JLRTB02001NAS1 TECHNICAL BULLETIN

INFORMATION			
SECTION:			
01-03			
SUBJECT/CONCER	N:		
ailgate Does Not	Open Fully		
AFFECTED VEHICL	E RANGE:		
MODEL:	MODEL YEAR:	VIN:	ASSEMBLY PLANT:
E-PACE (X540)	2018-2020	Z00381-Z78385	Graz (Austria)
MARKETS:			
IORTH AMERICA			
CONDITION SUMM	ARY:

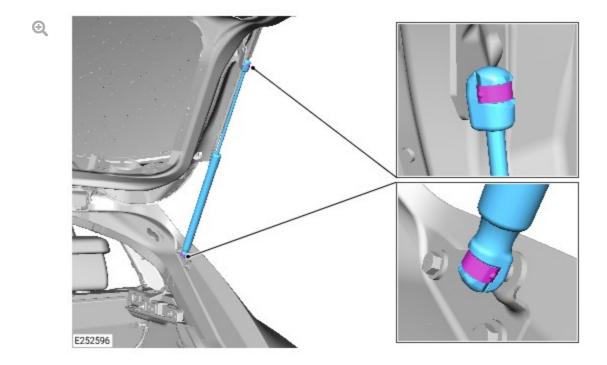
Incorrect specification tailgate struts have been installed to the vehicle. A new service part is now available with improved opening performance. **Suggested customer concern code** -

Renew the tailgate strut with the new higher specification tailgate strut.
